ADDENDUM 01

TO	All Plan Holders	ISSUE DATE	20 November 2022
		PROJECT #	17-006.12

REGARDING **Reroof & Mechanical, Exterior Painting, Window Replacement at Mission Hill Middle School** **NARRATIVE PAGES**

Building **AD1-A2.1**

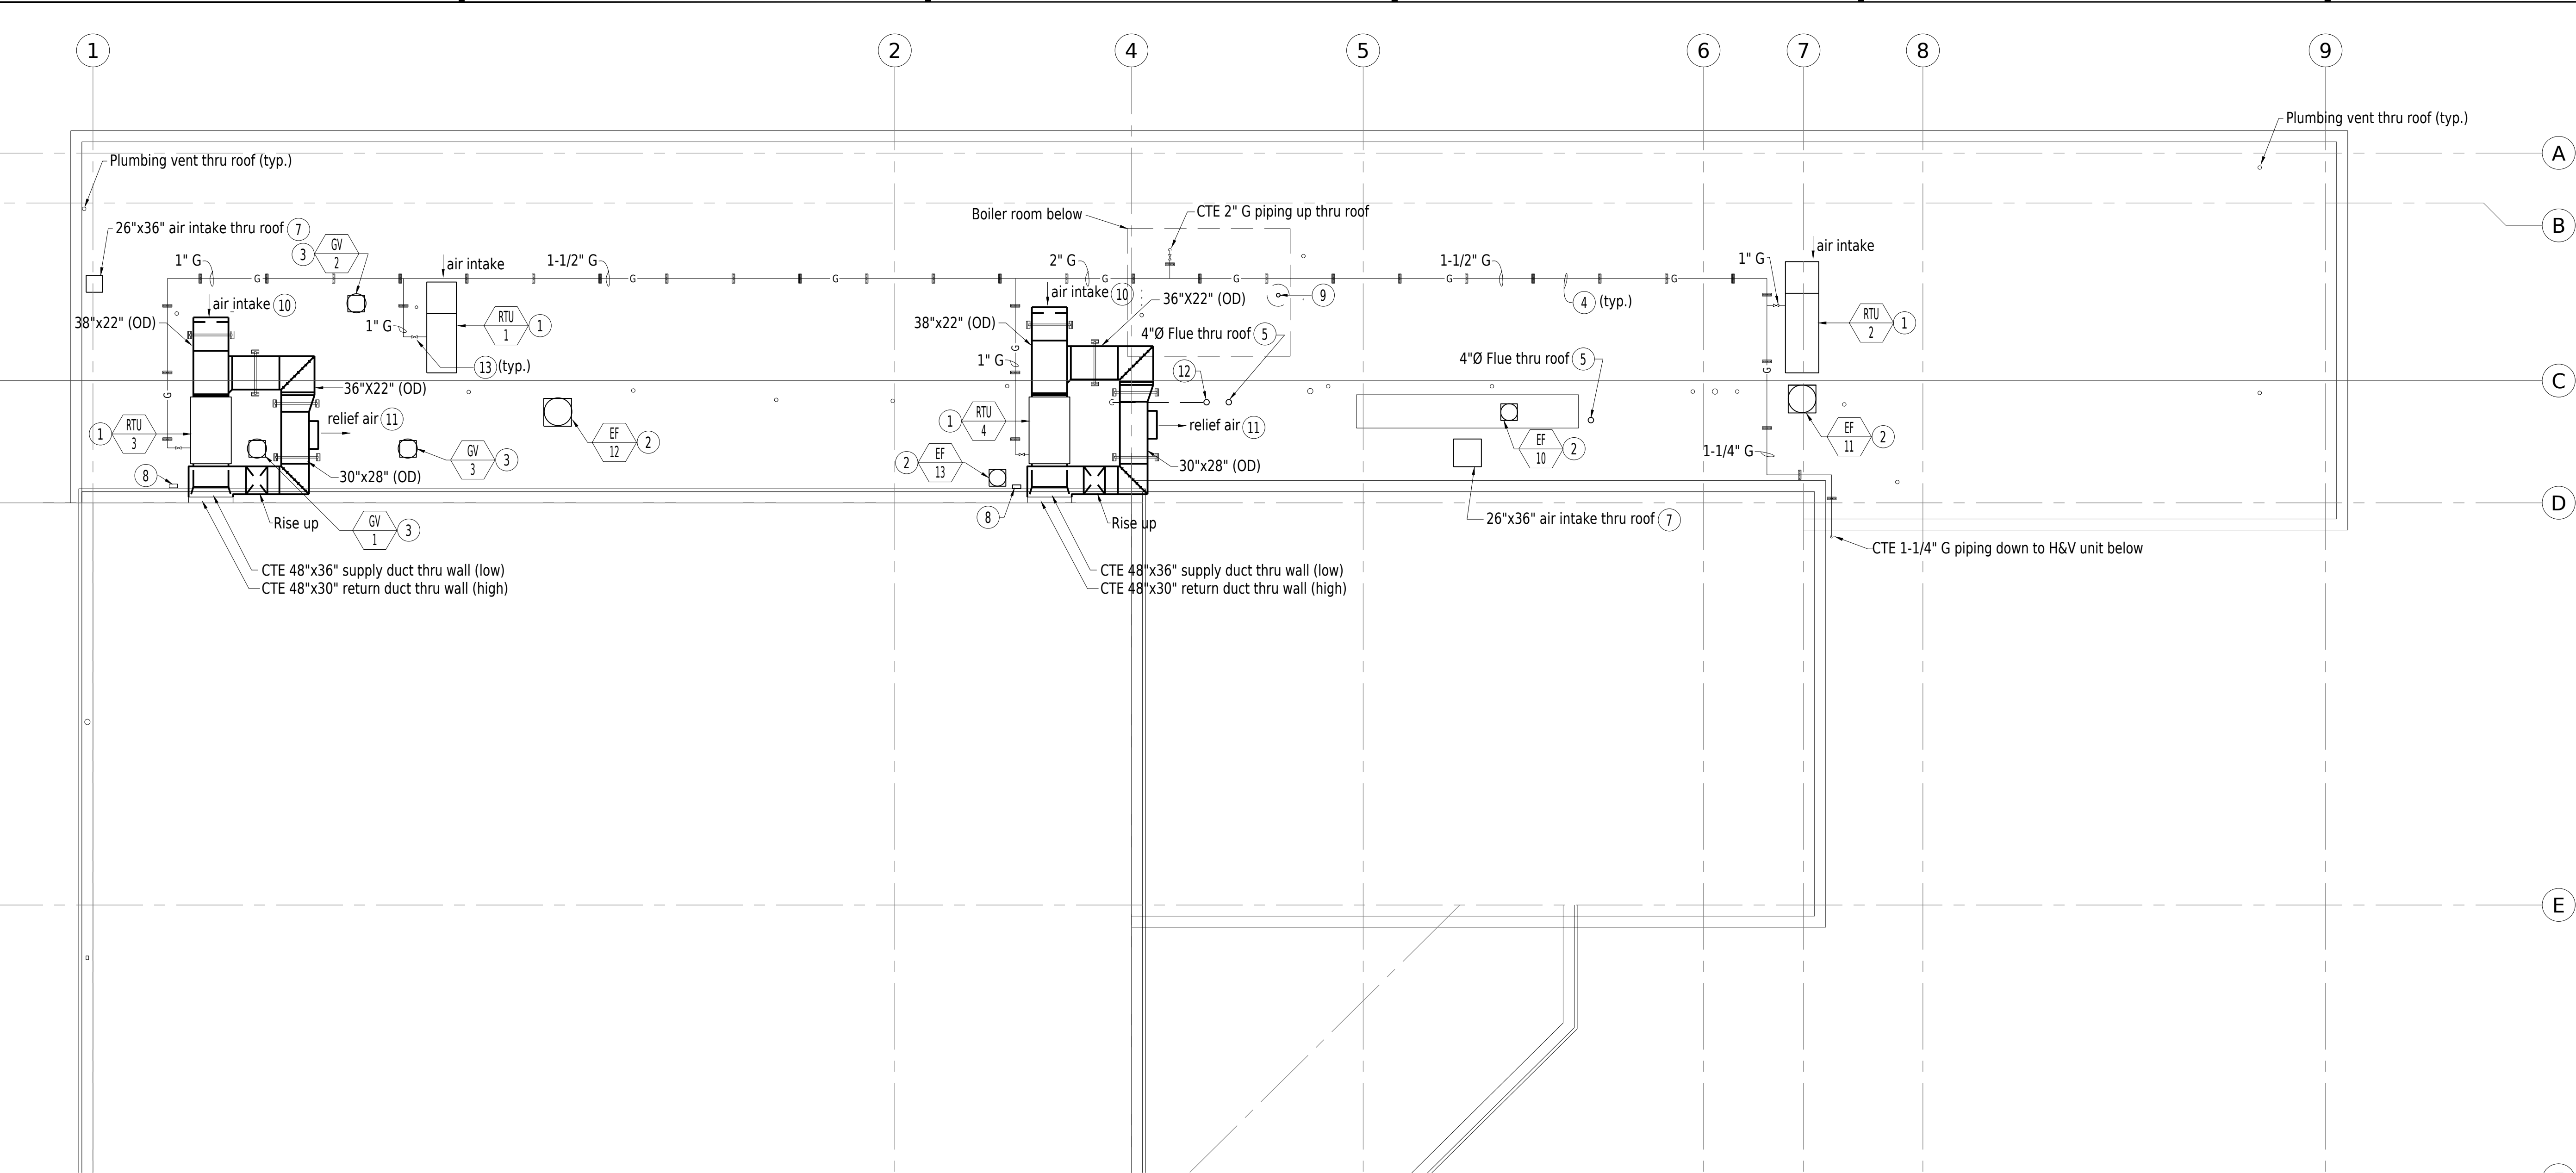
07 AD 1-2.1 ***This scope is added as bid Alternate 03***

Remove peninsula and island cabinets in rooms 9,11,12,13 as indicated

- Remove peninsula and island cabinets as indicated
- Disconnect and safe off all electrical, plumbing, gas connections.
- Patch floor as necessary with plywood sheathing and New 12" x 12" VCT to match existing.
- Patch and paint wall to match adjacent surfaces.

AD1-M2.1

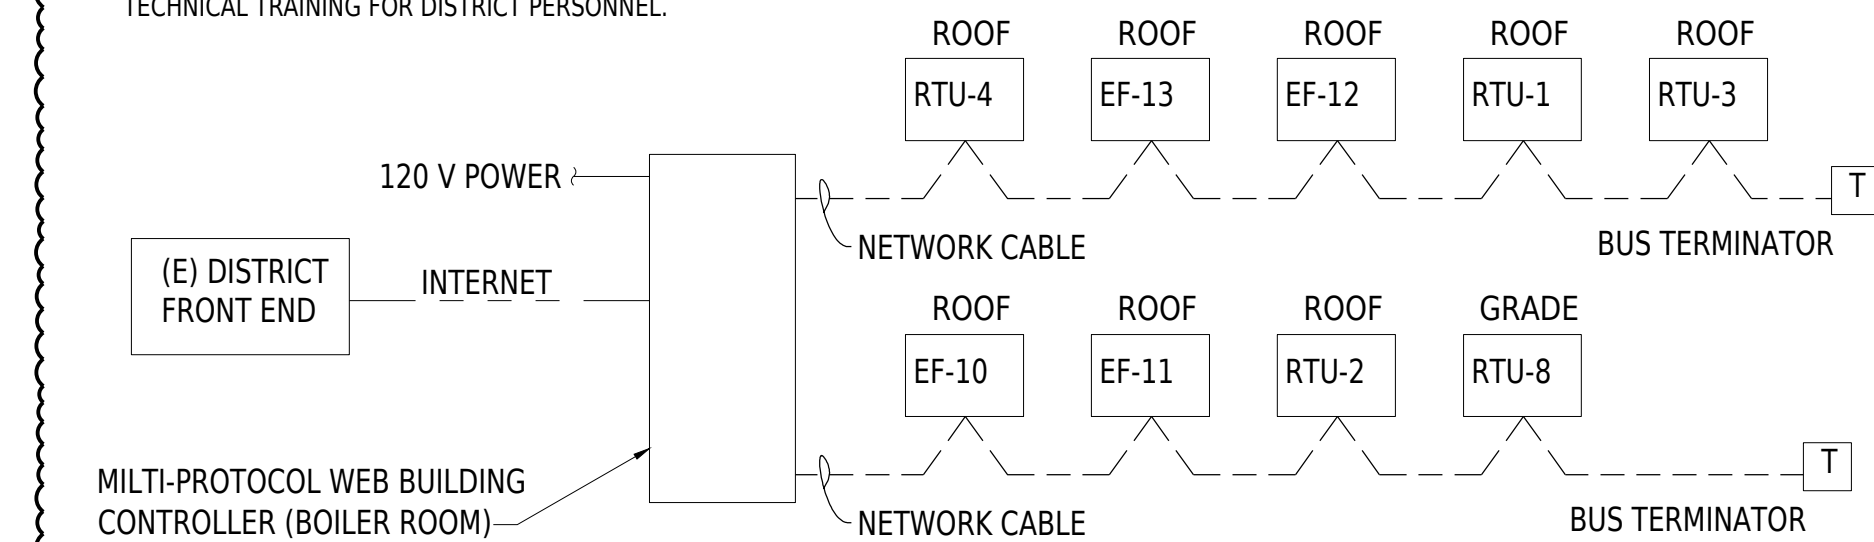
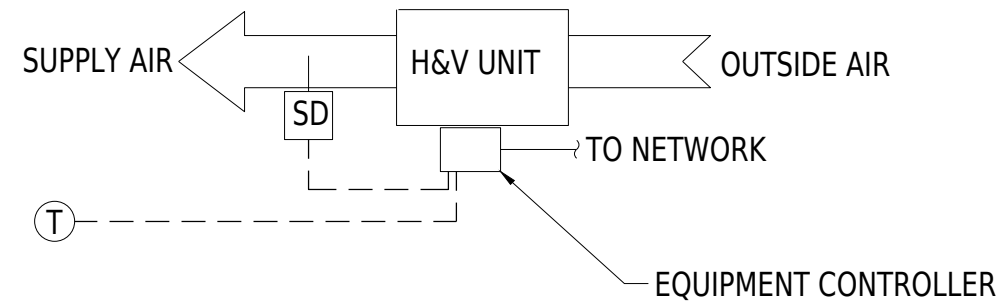
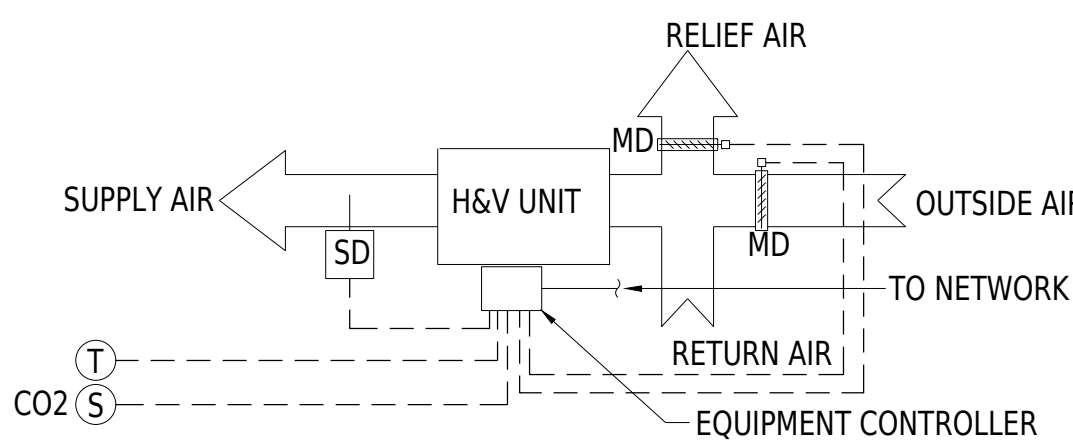
05	AD1-M2.1 <p>Add</p> <p>Mechanical Sheet M2.1 is hereby revised to indicate required mechanical controls.</p> <p><i>Revised sheet index to be issued in conform set after DSA Approval of addenda</i></p> <p>Roofing Scope at Area of New Egress</p>
D2.0	<ul style="list-style-type: none">• Remove and replace roof sheathing as necessary to install any new blocking / structure to be installed as required for new walkway.
01 64 00	Roofing materials to be purchased by district and provided to Contractor
00 70 00	Courtesy Clarification: Note Scope of work Summary / Milestone dates indicated in this section. Work on roof adjacent to existing Auditorium window s must be completed prior to installation of windows.
